TECHNICAL BULLETIN

[Issue No.] FA-A-0117

[Title] Compliance with the new Radio Waves Act (South Korea)

[Relevant Models] MELSEC-Q/L/QS/WS/AnS, CC-Link, and CC-Link/LT series, PC interface boards*

Figure 1 Example of a new rating plate

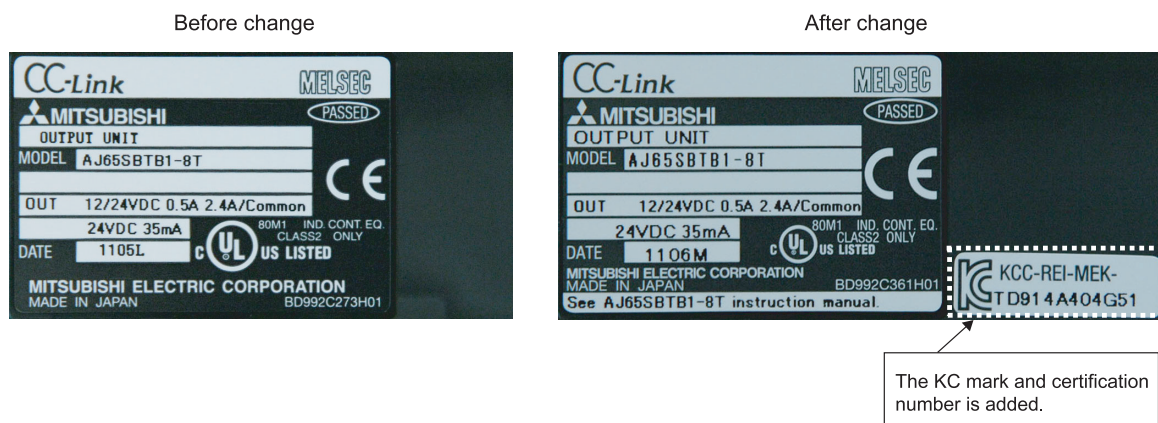
(1) Placing the KC mark and certification number on both product (rating plate) and package

Figure 3 Precautionary note in Korean

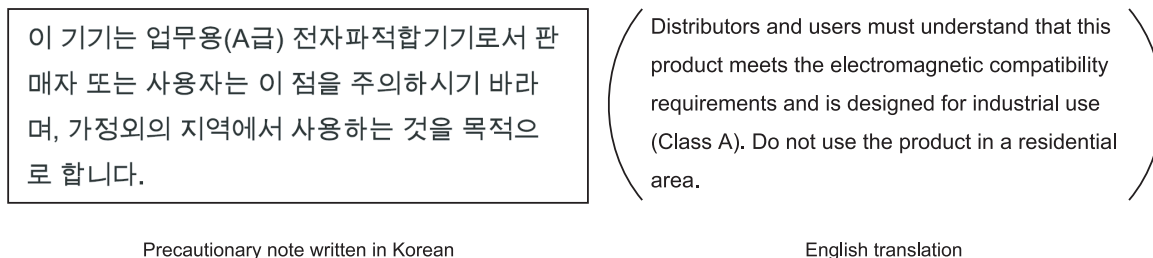
(2) Providing handling precautions in Korean

Precautions for handling products have been available on the following website since August 1, 2011.

Until the end of July, the following precautionary note was provided with each product.
